## **SERVICE BULLETIN**

# <sub>N°</sub> 169-148

**REV.:** A - September 5, 2019

#### ATA 64 - TAIL ROTOR FLIGHT CONTROL IMPROVED PERIODICAL INSPECTION

Figure 1

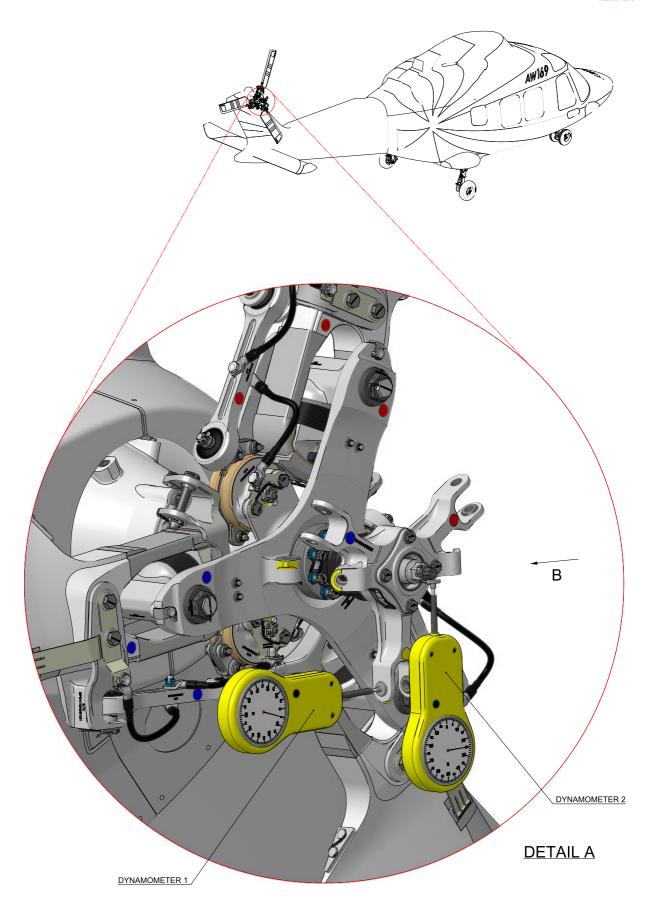
With reference to Figure 1 and Figure 2 View B and Detail C, apply a  $25 \pm 2.5$  N upward force on the squared rod end by means of a dynamometer while performing the instructions reported in steps from 7.3 to 7.7. It is allowed to apply the force either pushing or pulling the rod end with the dynamometer.

- slight rotation of the spider occurs (see Figures 1 and 2 for further details and dynamometer positioning). Record the force measured on Table II (refer to Figure 8).
- 7.5 Repeat step 7.4 for the opposite spider rotation on the same arm, pushing leftward the dynamometer gauge from the vertical position of the spider arm. Record the force measured on Table II (refer to Figure 8).
- 7.6 Repeat steps 7.4 and 7.5 for all the other two spider arms.
- 7.7 The force detected by dynamometer on steps 7.4 thru 7.6 shall be measured within 1.6 N and 8.8 N.
- 8. If none of the checks performed in step 7 fails proceed as follows, otherwise skip to step 9.

Figure 4

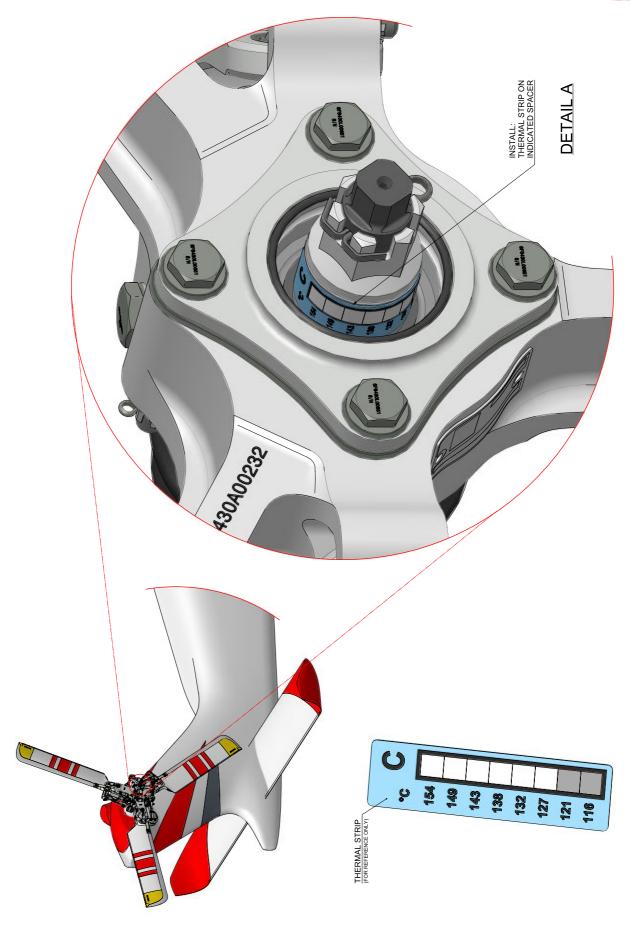
3.3 With reference to Figure 4, with the help of a non metallic spatula, perform the installation of the thermal strip on the surface of the spacer control rod P/N 4F6430A02551.

- 4. With reference to Figure 4, check the temperature reached by the thermal strip installed on spacer control rod P/N 4F6430A02551. Make sure that the temperature has not reached a value equal to or above 121°C. Record the check result on Table III (refer to Figure 9).

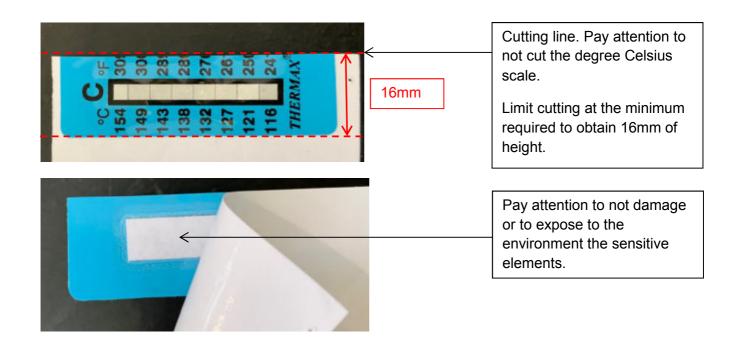
Do not use a thermal strip if after having trimmed it, its sensitive element is exposed to air. See below an example of a badly cut strip.

Figure 6

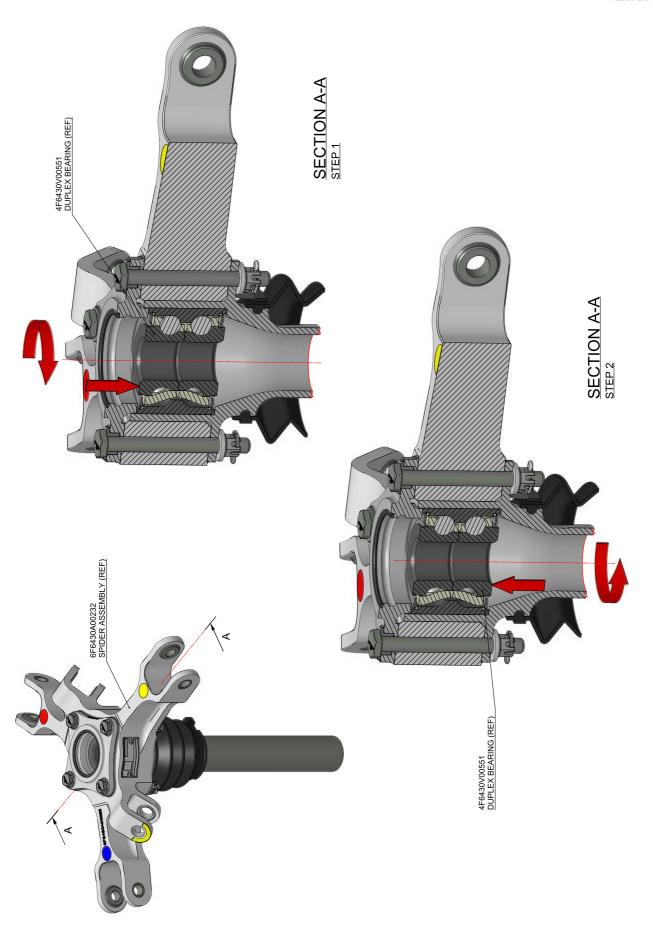
- 5.2 With reference to Figure 6 section A-A Step 1, push the top inner race down and at the same time turn it to feel if there is roughness.
- 5.3 Put your finger into the duplex bearing until you can pull up the lower face of the inner race.

- 5.4 With reference to Figure 6 section A-A Step 2, pull the bottom inner race in the up direction and at the same time turn it to feel if there is roughness.
- 5.5 Repeat the Step 5.1 thru Step 5.4 at least one time to confirm the results.
- 5.6 Record the results of the previous steps on Table V (refer to Figure 11).

Figure 1a

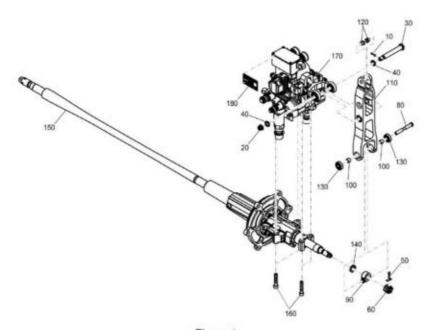
To check and re-apply the torque of the castellated nut (60) connecting the rod (150) to the input lever (110) of the Tail Rotor Actuator (see Fig. 1a and 1b).
